# Product Support Bulletin 2020-002

## Maintenance of Way ~ Work Equipment Bulletin

**SUBJECT:** Replacement of Axle Bearing Mounting Bolts.

**MACHINE MODEL(S):** Ride on Tie Plugger (RTP)

FIGURE 1

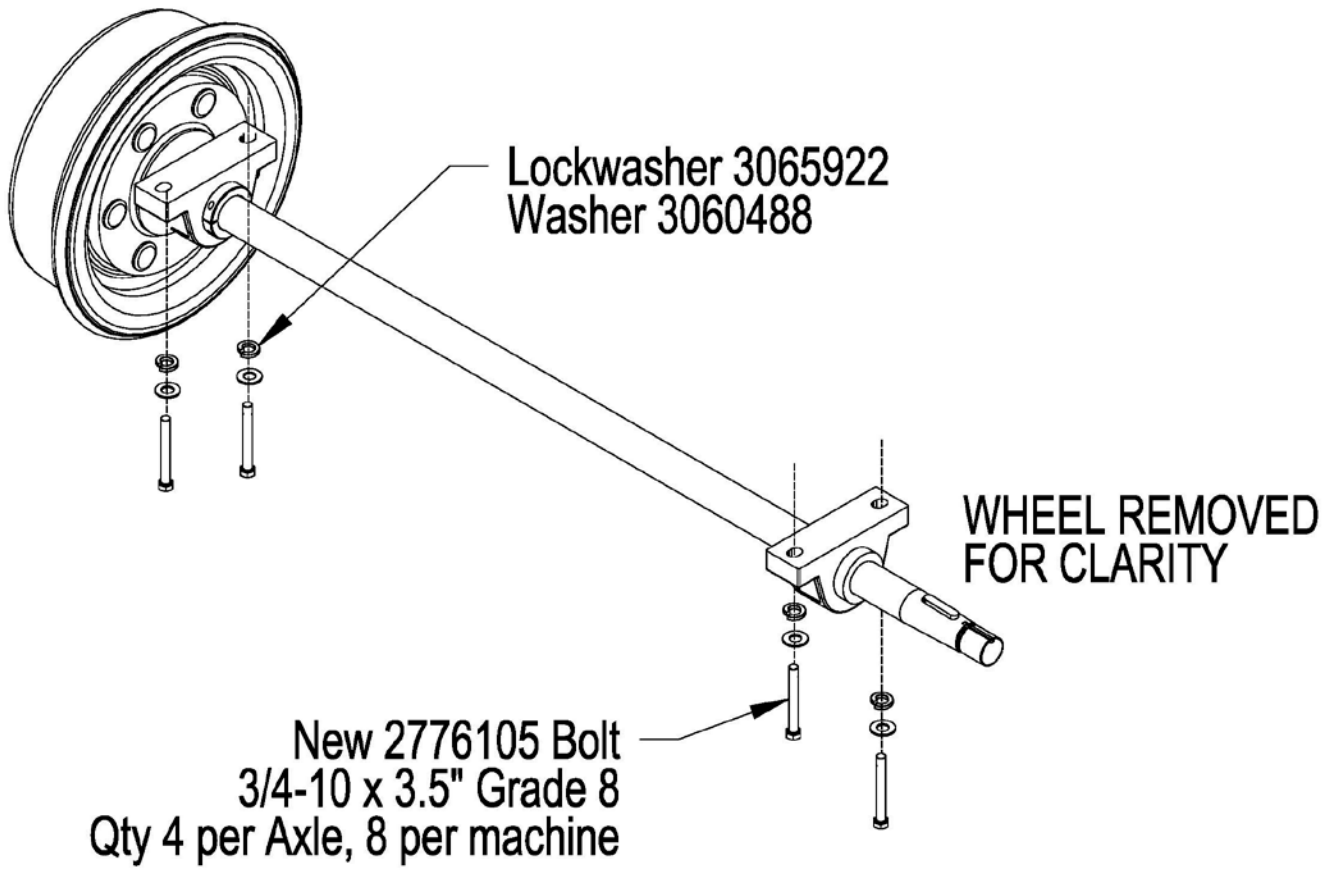
**SUMMARY:** The original bolts used to mount the axle bearings to the frame were 4" long. At this length, there was a potential of the bolts shearing off during certain activities. One example of this would be when loading machines on to scorpion cars.

**OPERATIONAL IMPACT:** Replacing the original 3/4"-10 x 4" Grade 5 axle bearing mounting bolts with 3/4"-10 X 3.5" Grade 8 bolts will help prevent the bolts from shearing off.

**ACTION:** Remove the existing 3/4"-10 x 4" Grade 5 axle bearing mounting bolts one at a time and replace them with 3/4"-10 X 3.5" Grade 8 bolts P/N 2776105 and torque them to approximately 380ft. lbs. There are two bolts per bearing and a total of eight bolts per machine, allow approximately one hour per machine for change out. See Figure 1.
